## PRELIMINARY PERCOLATION APPROVAL LETTER 2012-PERC-7260

Les Coble (RE: J. Sidoti) 425 Cove Tower Dr Unit 1503 Naples, FL 34110

Property ID: 6012175

RE: Sidoti/Raimond property, Map 21 Parcel 43, Rt. 404 at Rt. 480

IN THE SIXTH ELECTION DISTRICT CAROLINE COUNTY, MARYLAND

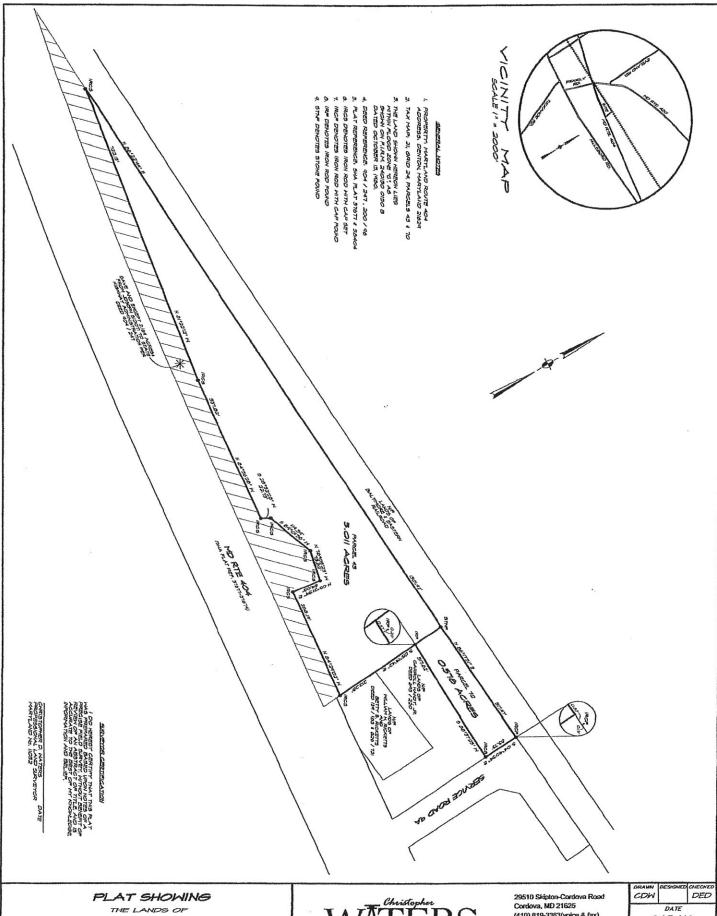
General	Sewage Reserve Area Note Required on all plats depicting a SRA
To be prepared by licensed surveyor/engineer	"The Sewage Reserve Area(s) (SRA) shown hereon must remain undisturbed for sewage disposal purposes only. This area shall be exclusive of buildings,
To be prepared by person capable of preparing scaled site plan	easements, right-of-way, or any other permanent or physical objects. Any
Building envelope (5000 sq ft) or footprint of planned house	construction activity or other use that may adversely affect this use as a sewage reserve area may render any or all Health Department approvals null and void."
Any field drains or agricultural tiles within 150' of the property.	reserve area may render any or an rieann bepartment approvais non and void.
🗔 2' contours, topography	Sewage Reserve Area (SRA)
1' contours, topography	Show 10,000 sq ft minimum SRA-(minimally required for a 4 bedroom

☑ 0.5' contours, topography	home)-refer to preliminary approval letter for SRA size
₩ Water wells within 150' of the property line	Show 6600 sq ft minimum SRA (Minimally required for a 4 bedroom home)
☑ Septic systems within 100' of the property line	Design an initial and 1 replacement sewage disposal system based on minimum specifications (contact a sanitarian if minimum specifications are not
🔀 Locations and dimensions of all structures existing and proposed on the property;	enclosed) and submit to this office
i.e. decks, sheds, garages, driveways, patios, porches, walks, swimming pools	Design 3 sewage disposal systems in the approved SRA using the enclosed
Storm Water Management, if required. Final plat approval will not be granted	minimum specifications. Contact a sanitarian if not enclosed.
until storm water management plans are approved.  Exclusive of Wetland or Sensitive Area buffers	SRA must be platted and recorded in land records

Location of property corners, lot lines with property dimensions (provide copy of record plat).	Design must include septic system design elevations (i.e. finish floor of house and septic system pipe invert elevations from sewer house connection to distribution box.
	Location of test sites. label as TP (Test Pits), SB (Soil Boring), PT (Perc
Water Supply	Test), SMT (Sand Mound Test), P (Piezometer)
Propose Wells	Location or proposed or approved SRA
Acquisition of Groundwater Appropriation Permit for Major Subdivisions (>10 lots) on individual wells and all commercial projects	Locate proposed SRA's in the vicinity of the test sites, perpendicular to slope and at same elevation or higher than the ground at the lowest piezometer.
50' SRA to well	Show a 10' Building Restriction Line (BRL) for the SRA. The BRL must be
100' SRA to well	20' if basements are planned (Major subdivisions only).
150' SRA to well	Proposed Septic Tanks, Lift Chambers, and Distribution Boxes

15' ROW to well	Sewer House Connection
☐ 30' Home Improvements to well	100' from field drain
25' Pool to well	150' from field drain
10' Property Line to well	☑: 100' from groundwater penetrating ditch
Well Site Accessibility	150' from groundwater penetrating ditch
······································	25' to swales or drainage ways
Notes to be added to plat general notes section	25' steep slop (>25%)
"All lots are approved for a minimum 4 bedroom home (600 Gal./Day, design flow)	50' to drilled wells
+/- 3500 sq.ft.), unless specified otherwise"  I in ground swimming pools are not permitted less than 25' from Septic Reserve	100' to drilled/shallow wells
11 in ground swimming pools are not permitted less than 25 from Septic Reserve Area"	10' from property lines
"No permanent structures are permitted in the Septic Reserve Area"	☐ If approved for sand mound construction, include 25' "noncompaction zone"

There are no wells or septic systems within 150 feet of property lines unless	around SRA
otherwise shown"	If approved for tile line construction, 20' from building foundations/envelope,
shown hereon is located in the Chesapeake Bay Critical Area. All onsite sewage disposal (septic) systems serving newly constructed buildings and all replacement	10' is required if building is on crawl space or slab  Label SRA as "Approved for Sand Mound" if so approved
risposal (septic) systems serving newly constructed buildings and all repracement septic systems must include Best Available Technology (BAT) for removing introgen.	Laber SRA as Approved to Sand Mountains approved  If initial septic system is a different design than the replacement systems,
	label accordingly

Must Identify all ditching surrounding this parcel and inlets and outlets of the drainage systems surround this parcel
